# **Planning Commission**

Wednesday, January 7, 2026

# TECHNICAL REVIEW PLAT REQUIREMENTS REGULAR PLANNING COMMISSION MEETING January 7, 2026

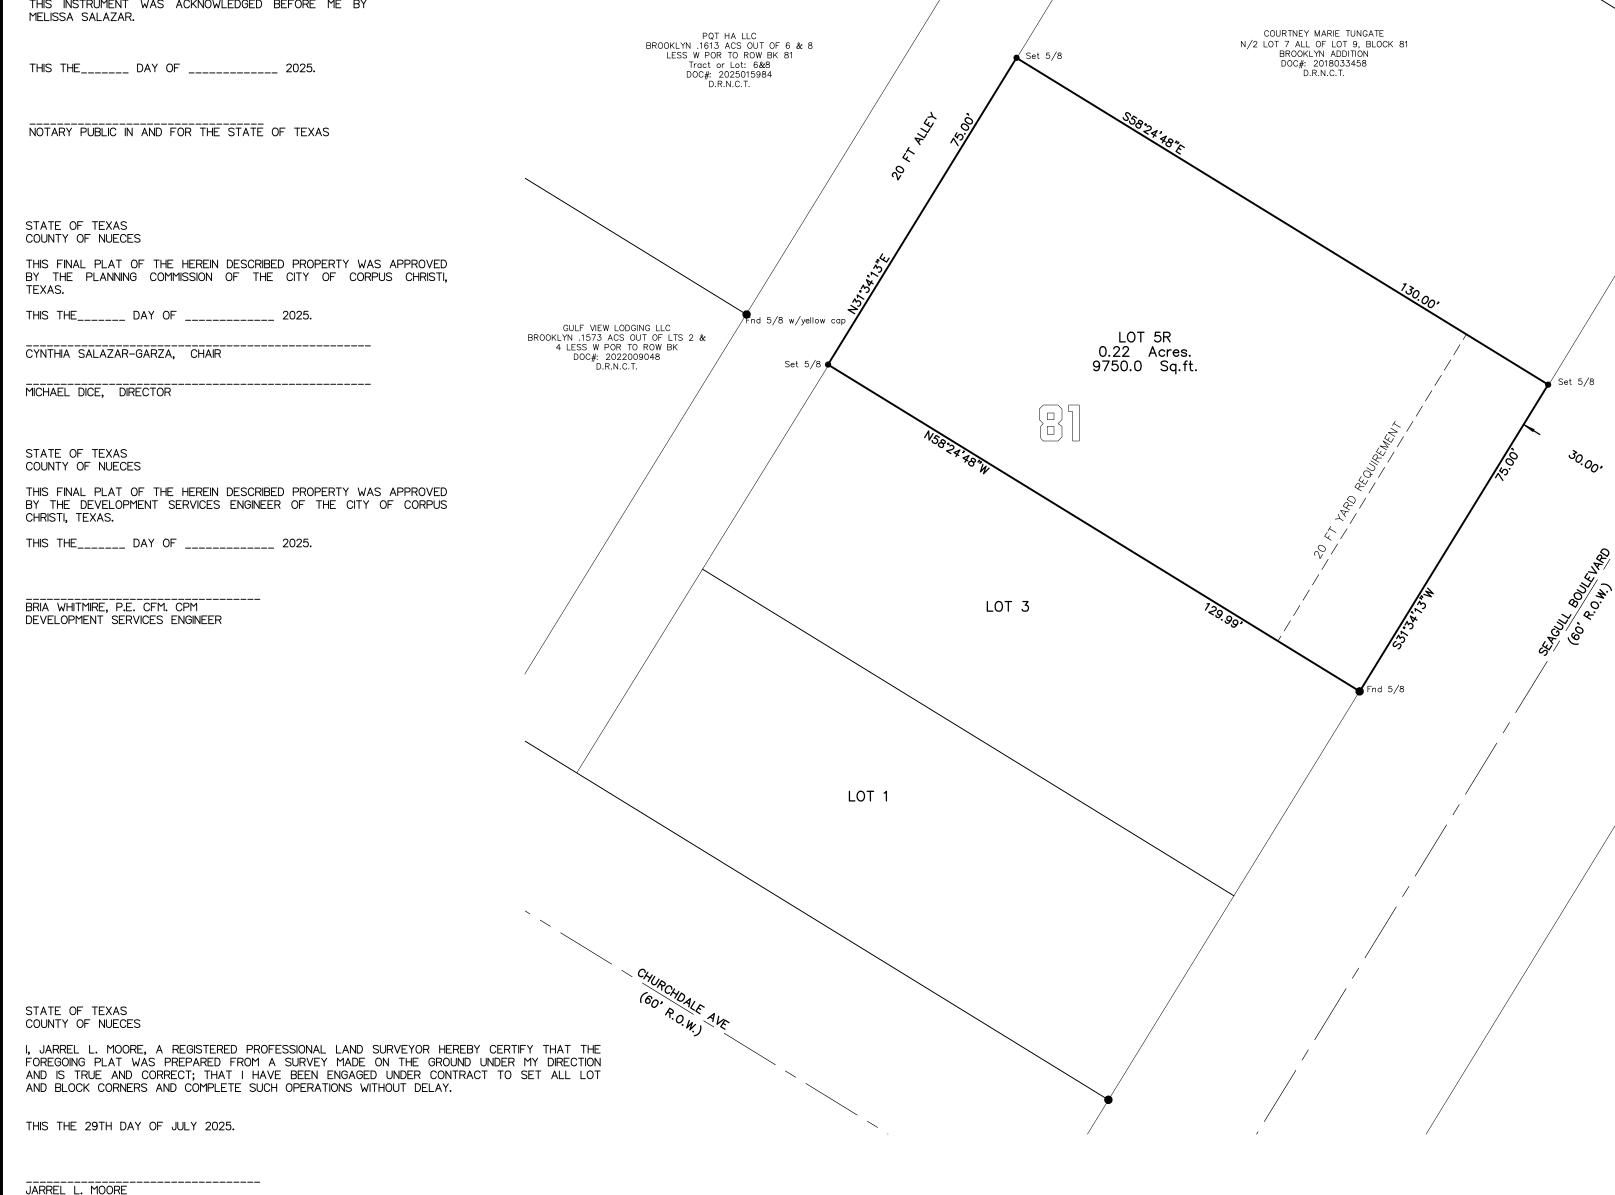
Comment ID	Author : Department	Status	Review Comments	Applicant Response Comments
8	Alex Harmon : DS	Closed	Improvements Required for Recordation, per UDC 8.1.4. A. Streets: No Sidewalks: No B. Water: No Fire hydrants: No C. Wastewater: No D. Stormwater: No E. Public open space: No F. Permanent monument markers: No Please note, improvements required should be constructed to city standards, found in Article 8 and the IDM.

Comment	Page Reference	Annotation	Author : Department	Status	Review Comments	Applicant Response Comments
ID		Туре		1		
7	P002	Note	Alex Harmon : DS	Closed	Show 2" gas line on utility map.	
1	Utility	Note	Mark Zans : LD	Closed	Please change language to "was approved by the Planning Commission of the city of Corpus Christi, Texas"	
2	Utility	Note	Mark Zans : LD	Closed	Change Michael Dice title to Director.	
3	Utility	Note	Mark Zans : LD	Closed	Add Cynthia Salazar-Garza name and title of Chair and provide signature line.	
4	Utility	Note	Mark Zans : LD	Closed	Add lot number (Lot 5R), and square footage of lot	
5	Utility	Note	Mark Zans : LD	Closed	Provide half street dimension.	
6	Utility	Note	Mark Zans : LD	Closed	At this time the alley way is not included in the property obtained by the owner and shall not be built or encroached upon.	
9	Utility	Note	Mark Zans : LD	Closed	At this time the alley way is not included in the property obtained by the owner and shall not be built or encroached upon.

Comment ID	Page Reference	Annotation Type	Author : Department	Status	Review Comments	Applicant Response Comments
					The fire department shall not be deterred or hindered from gaining immediate access to fire protection equipment or fire hydrants. Note: Hose lay from a hydrant will not cross an arterial street. 5□Infor.□912.2.3 (amendment) Proximity to Hydrant: Fire department connections (FDC) for each sprinkler system or standpipe system shall be located not more than 100 feet from the nearest fire hydrant connected to an approved water 6□Infor.□503.1.1 (amendment) Buildings and facilities: Approved fire apparatus access roads shall be provided for every facility, building, or portion of a building hereafter constructed or moved into or within the jurisdiction. The fire apparatus access road shall allow access to three (3) sides of buildings in excess of fifteen thousand (15,000) square feet and all sides for buildings in excess of thirty thousand (30,000) square feet. 7□Infor.□3310.1 Required access. Approved vehicle access for firefighting shall be provided to all construction or demolition sites. Vehicle access shall be provided to within 100 feet of temporary or permanent fire department connections. Vehicle access shall be maintained until permanent fire apparatus access roads are available. 8□Infor.□D102.1 Access and loading. Facilities, buildings, or portions of buildings hereafter constructed shall be accessible to fire department apparatus by way of an approved fire apparatus access road with an asphalt, concrete or other approved driving surface capable of supporting the imposed load of fire apparatus weighing at least 75,000 pounds. 9□Infor.□503.1.1 (amendment) Buildings and facilities: During construction, when combustibles are brought on to the site in such quantities as deemed hazardous by the fire official, access roads and a suitable temporary supply of water acceptable the fire department shall be provided and maintained. 10□Infor.□Note: An accessible road and a suitable water supply is required once construction materials are brought on site.

Applicant Response Comr	Review Comments	Status	Author : Department	Annotation Type	Page Reference	Comment ID
	feet 6 inches.  12□Infor.□D103.1 Access road width with a hydrant. Where a fire hydrant is located on a fire apparatus access road, the minimum road width shall be 26 feet, exclusive of shoulders.  13□Infor.□'The minimum required width of 20 feet that shall be maintained means a clear unobstructed path that allows the passage of fire apparatus.  1.□Where Fire Apparatus Access is constructed to the minimum of 20 feet, no parking is allowed within the fire apparatus lane.  2.□Where a fire hydrant is located on the street, the minimum unobstructed clearance shall be 26 feet. In this instance, no parking is allowed on one side of the street.  3.□The minimum UDC residential street width is 28 ft. curb to curb. Any parking along the street that reduces the width to less than 20 ft. is prohibited and the Fire Code Official and will require painting "NO PARKING-FIRE LANE" along one side of the street."  14□Infor.□'Note: Calculated Turning Radii for Fire Apparatus: Inside Turn: 20 ft. 3 in.  Curb to curb: 36 ft. 8 in.  Wall to wall: 44 ft. 8 in.  Note: The turning radius for fire apparatus should not be less than 45 degrees and curb to curb 36 feet. As a result, developers should be particuarly careful not to design streeets with acute angles that would prevent fire apparatus from completing a turn without having to back up to negotiate the turn."  15□Infor.□D105.1 Where required. Where the vertical distance between the grade plane and the highest roof surface exceeds 30 feet, approved aerial fire apparatus access roads shall be provided. For purposes of this section, the highest roof surface shall be determined by measurement to the eave of a pitched roof, the intersection of the roof to the exterior wall, or the top of parapet walls, whichever is greater  16□Infor.□D105.2 Width. Aerial fire apparatus access roads shall have a minimum unobstructed width of 26 feet, exclusive of shoulders, in the immediate vicinity of the building or portion thereof.

Comment ID	Page Reference	Annotation Type	Author : Department	Status	Review Comments	Applicant Response Comments
					17 Infor. ID105.3 Proximity to building. At least one of the required access routes meeting thiscondition shall be located within a minimum of 15 feet and a maximum of 30 feet from the building and shall be positioned parallel to one entire side of the building. The side of the building on which the aerial fire apparatus access road is positioned shall be approved by the fire code official.  18 Infor. ID105.4 Obstructions. Overhead utility and power lines shall not be located over the aerial fire apparatus access road or between the aerial fire apparatus road and the building. Other obstructions shall be permitted to be placed with the approval of the fire code official.  19 Infor. ID503.4 Obstruction of fire apparatus access roads. Fire apparatus access roads shall not be obstructed in any manner, including the parking of vehicles. The minimum widths and clearances established in sections D103 shall always be maintained.  20 Infor. ID503.3 Marking: Where required by the fire code official, approved signs, or other approved notices the include the words NO PARKING-FIRE LANE shall be provided for fire apparatus access roads to identify such roads to prohibit the obstruction thereof. The designation of a fire lane can be marked with conspicuous signs which have the words:" Fire Lane-No Parking" at 50-foot intervals. In lieu of signs, fire lanes may be marked along curbing with the wording, "Fire Lane-No Parking" at 15-foot intervals.

### GENEVA HEIGHTS, BLOCK 2, LOT 1A

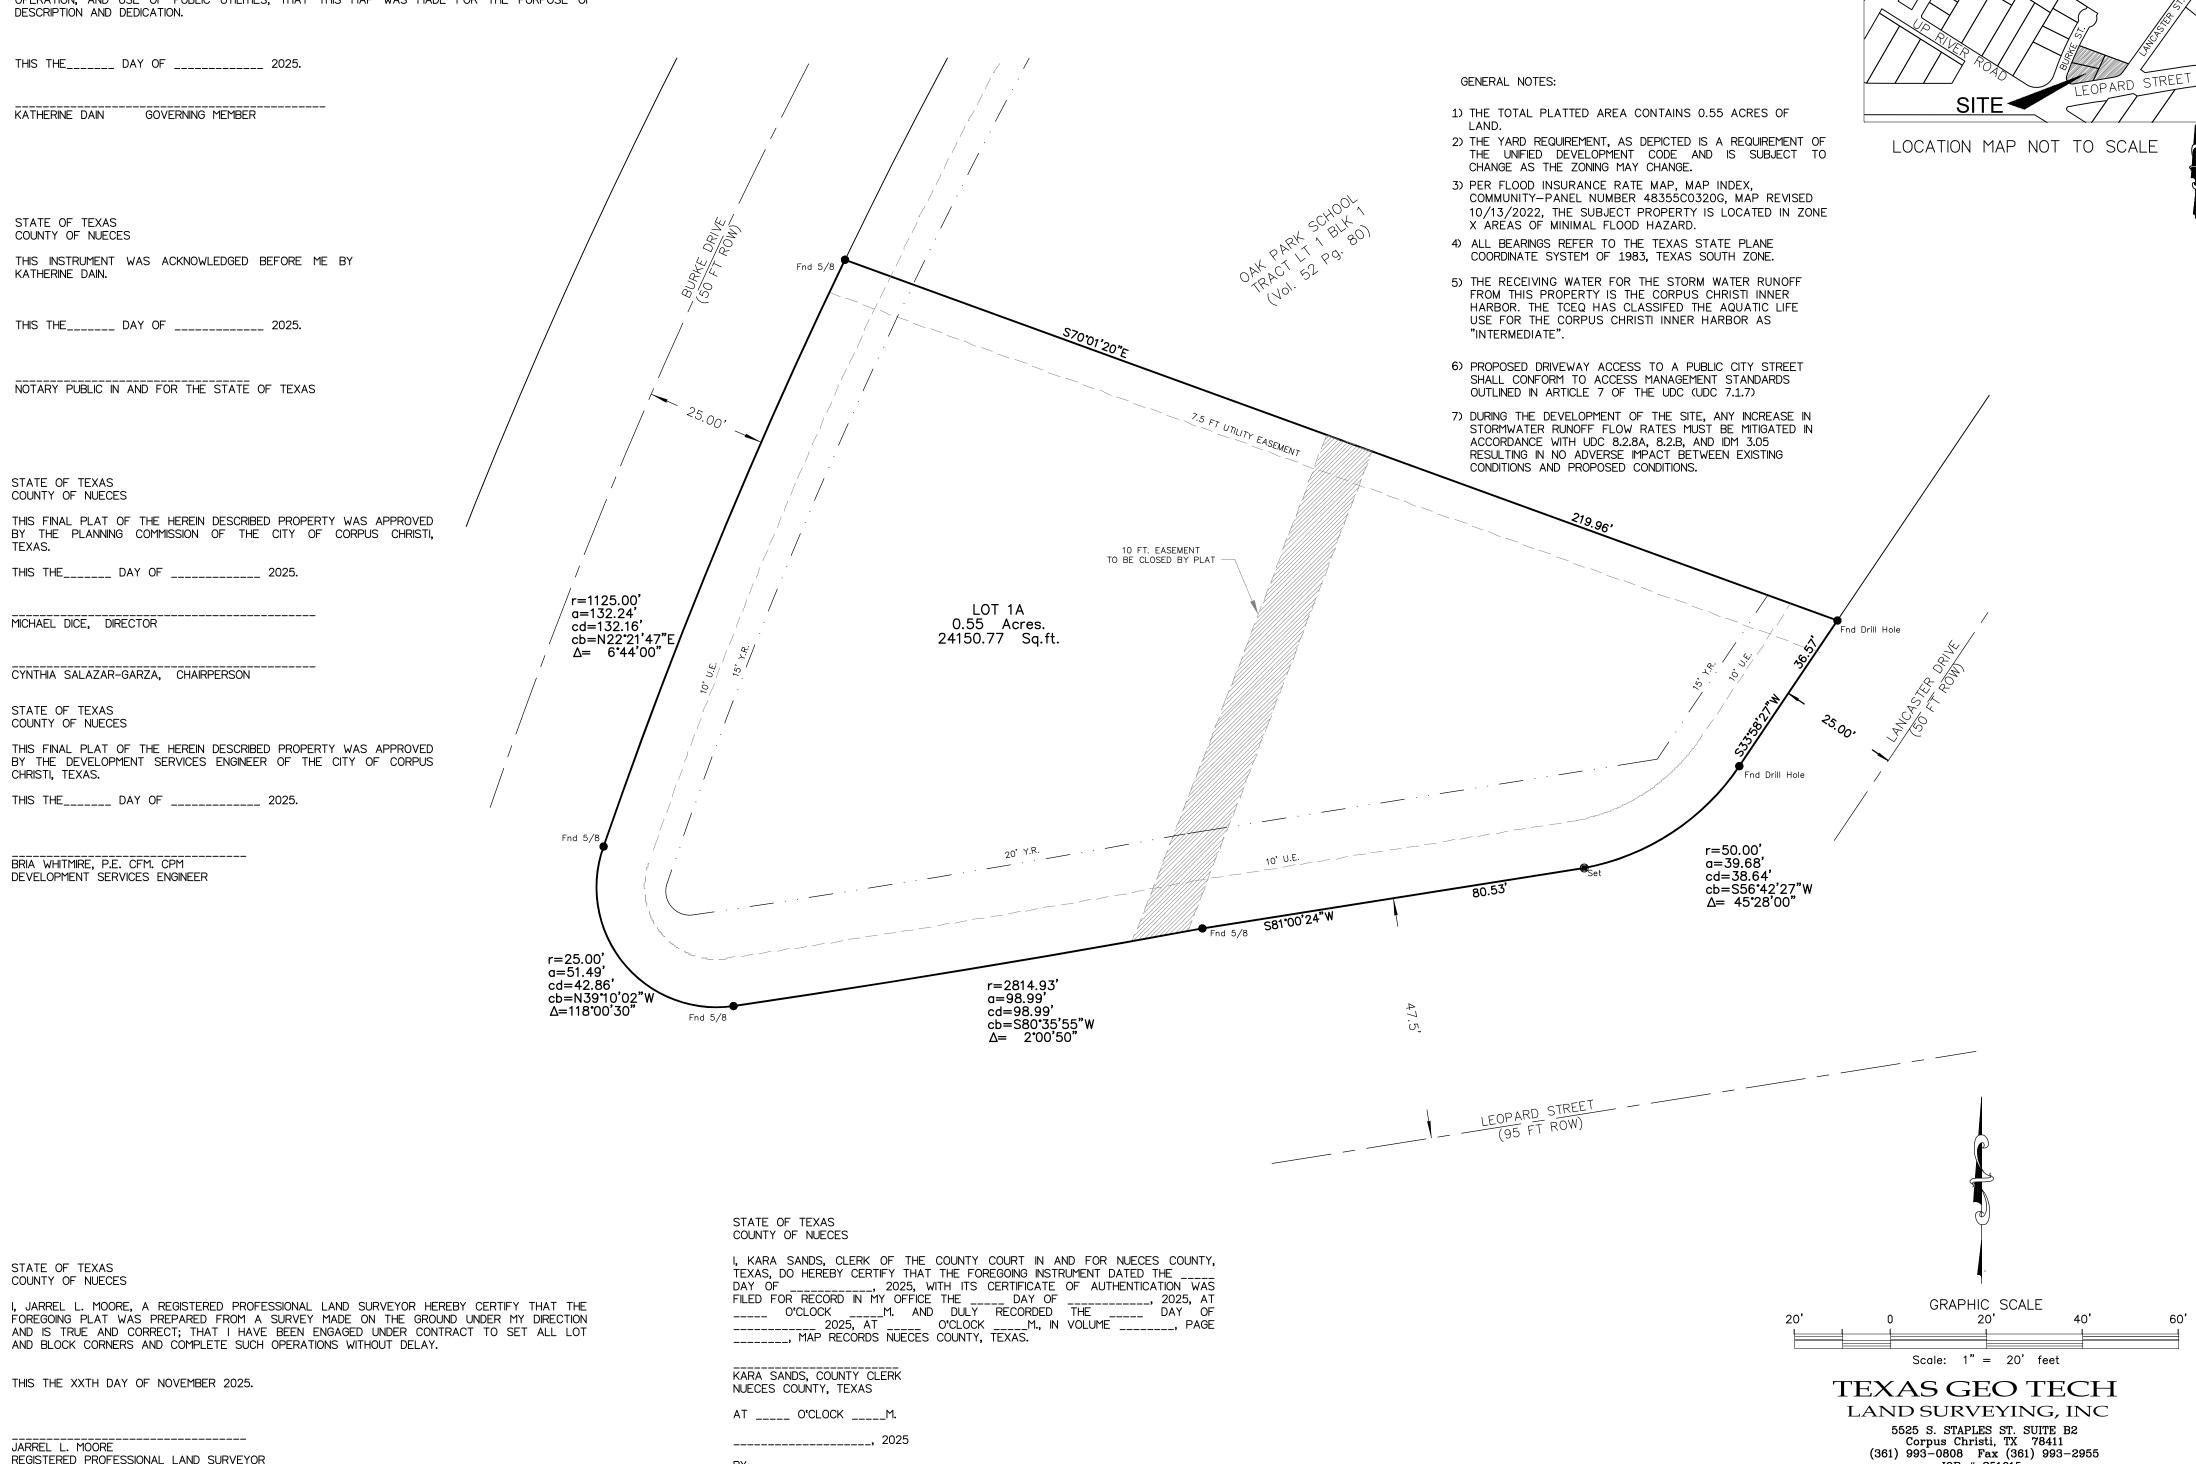
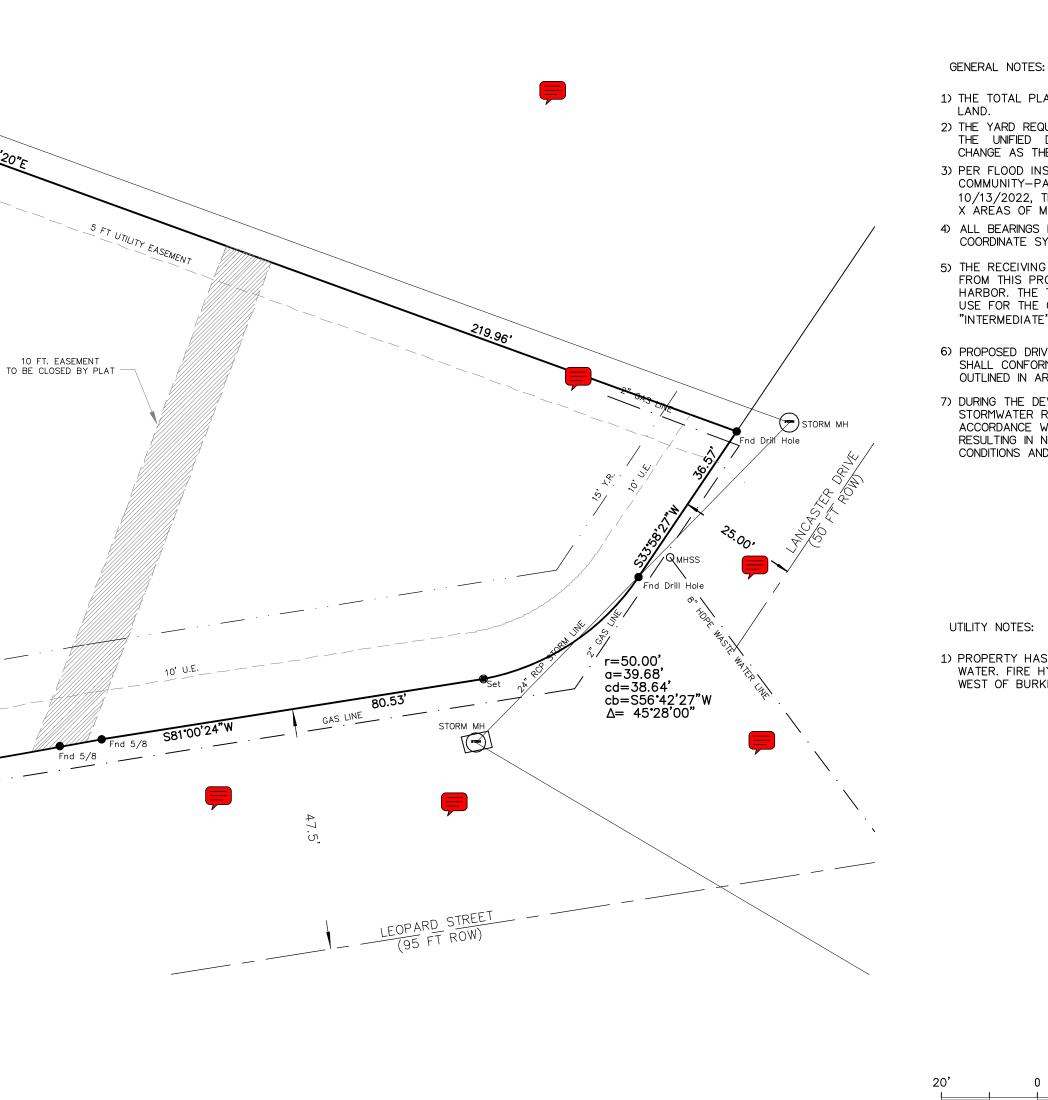
Comment ID	Author : Department	Status	Review Comments	Applicant Response Comments
2	Alex Harmon : DS	Closed	Improvements Required for Recordation, per UDC 8.1.4. A. Streets: No Sidewalks: No B. Water: No, unless existing meter is not usable Fire hydrants: At site development C. Wastewater: No D. Stormwater: No E. Public open space: No F. Permanent monument markers: No  Please note, improvements required should be constructed to city standards, found in Article 8 and the IDM.

Comment ID	Page Reference	Annotation Type	Author : Department	Status	Review Comments	Applicant Response Comments
1	P001	Note	Alex Harmon : DS	Closed	12/5/25 UPDATE: Comment response says this was addressed, however, it is not reflected on plat.  Per UDC 8.2.3.A.4 increase rear easement from 5 ft	
8	P001	Note	Mina Trinidad : DS	Closed	to 7.5 ft.  Traffic/ROW: (Davin Davila) 12/15/25 Update: ROW Department has reviewed and acknowledge the comments, and we do not have any further comments for this plat. The easement that will be closed on the lot, ROW Department has no objection.	
					PLAT - REQUIRES ACTION:  1. Proposed Driveway access to public City Street shall conform to access management standards outlined in Article 7 of the UDC (UDC 7.1.7)  2. Proposed ROW to reflect as the street(s) design and their pertaining categories/ type as per Article 8 of the UDC (UDC 8.2.1)	
					INFORMATIONAL: PLAT DRIVEWAY ACCESS & ROW CONSTRUCTION PERMITS  3. Proposed Driveway access to public City Street shall conform to access management standards outlined in Article 7 of the UDC (UDC 7.1.7)  4. The developer / applicant can reach out to rowmanagement@cctexas.com for further assistance regarding the ROW Construction Permit they will be required to submit prior to any temporary and / or permanent driveway off the immediate roadways.  5. The ROW Construction permit must be submitted and approved prior to any form of construction within City ROW.  6. Any contractor working within City ROW without an approved ROW Construction Permit can be held in non-compliance and can be subject to a fee of \$1,500 per day of unpermitted work, as per City of Corpus Christi Municipal Code 49-112 (9).

9	P001	Note	Mina Trinidad : DS	Closed	(Informational) TxDOT: (David Brink) Leopard Street is no longer State- maintained. It has been formally turned over to the City of Corpus Christi.	
10	P001	Note	Mina Trinidad : DS	Closed	(Informational) TxDOT (Lucio Ramos) This plat is not on our state's trunkline system anymore, no comments.	
12	P001	Note	Mina Trinidad : DS	Closed	GIS: (Ziba Abbasian) Plat does not close within acceptable engineering standards.	
13	P001	Note	Mina Trinidad : DS	Closed	(Informational) Parks and Recreation: The plat in question describes the proposed land use for the plat to be used for a commercial institution. As no newly proposed dwelling units are to be created, no fees are to be applied.	
14	P001	Note	Mina Trinidad : DS	Closed	Change Michael Dice signature to "Director" instead of "Secretary." This change will be for all plats moving forward.	
15	P001	Note	Mina Trinidad : DS	Closed	Change Cynthia Salazar's signature block to "Cynthia Salazar-Garca, Chairperson"

Comment ID	Page Reference	Annotation Type	Author : Department	Status	Review Comments	Applicant Response Comments
20	P001	Note	Mina Trinidad : DS	Closed	(Informational) CCRTA: This plat is located along but not immediately adjacent to any existing or foreseeably planned CCRTA bus stops served by either bus Route 27 Leopard or Route 28 Leopard/Navigation.	
21	P001	Note	Mina Trinidad : DS	Closed	Correct "Leopard Street" label within site area location map.	
22	P001	Note	Mina Trinidad : DS	Closed	Insert arrow or notation indicating the shaded area is the site.	
24	P001	Note	Mina Trinidad : DS	Closed	(Informational) Astound: No facilities within easement.	
25	P001	Note	Mina Trinidad : DS	Closed	(Informational) Frontier: This area is not in Frontier area.	
26	P001	Note	Mina Trinidad : DS	Closed	(Informational) CCPD has no objections.	
27	P001	Note	Mina Trinidad : DS	Closed	(Informational) Spectrum: Charter does not have any facilities in the easement being closed therefore we have no objection.

28	P001	Note	Mina Trinidad : DS	Closed	15-foot corner yard requirement per CN-1 Neighborhood Commercial District standards.	
29	P001	Note	Mina Trinidad : DS	Closed	Increase site location map text and zoom more into subject property.	
5	U001	Note	Alex Harmon : DS	Closed	Verify alignment of 2" gas line. City records show it on subject lot not neighboring lot.	
6	U001	Note	Alex Harmon : DS	Closed	Show location of water meter that was found during site survey to verify no water construction is required.	
7	U001	Note	Alex Harmon : DS	Closed	Show stormwater line along Lancaster and Leopard	
11	U001	Note	Mina Trinidad : DS	Closed	CCW: (Edgar Diaz Ruiz)  12/15/25 Update: 1. Water construction is not required for platting (UDC1.2.1.D & 8.2.6; Water Distribution Standards). 2. Wastewater construction is not required for platting (UDC 1.2.1.D & 8.2.7; Wastewater Collection System Standards).  Please see below CCW's comments: 1. Water construction is required for platting (UDC 1.2.1.D & 8.2.6; Water Distribution Standards). 2. Wastewater construction is not required for platting (UDC 1.2.1.D & 8.2.7; Wastewater Collection System Standards).

Comment ID	Page Reference	Annotation Type	Author : Department	Status	Review Comments	Applicant Response Comments
					(Captain Mark Lewis) 1. Note: All code reference is based on currently adopted International Fire Code (IFC) 2021 and Corpus Christi Water Distribution Standards. 2. Commercial Development shall have a fire flow of 1,500 GPM with 20 psi residual Fire hydrant every 300 feet and operational. A fire hydrant will likely be needed. 3. 507.5.1 (amendment) Where Required: All premises, other than one-family detached dwellings, where buildings or portions of buildings are located more than 150 feet from a fire hydrant shall be provided with approved on-site hydrants and water mains capable of supplying the fire flow require by the fire official. The minimum arrangement being so as to have a hydrant available for distribution of hose to any portion of building on the premises at distances not exceeding 300 feet.

Comment ID	Page Reference	Annotation Type	Author : Department	Status	Review Comments	Applicant Response Comments
					apparatus weighing at least 75,000 pounds. 8. 503.1.1 (amendment) Buildings and facilities: During construction, when combustibles are brought on to the site in such quantities as deemed hazardous by the fire official, access roads and a suitable temporary supply of water acceptable the fire department shall be provided and maintained. 9. Note: An accessible road and a suitable water supply is required once construction materials are brought on site. 10. 503.2.1 Dimensions. Fire apparatus access roads shall have an unobstructed width of not less than 20 feet, exclusive of shoulders and an unobstructed vertical clearance of not less than 13 feet 6 inches. 11. D103.1 Access road width with a hydrant. Where a fire hydrant is located on a fire apparatus access road, the minimum road width shall be 26 feet, exclusive of shoulders 12. 503.4 Obstruction of fire apparatus access roads. Fire apparatus access roads shall not be obstructed in any manner, including the parking of vehicles. The minimum widths and clearances established in sections D103 shall always be maintained.
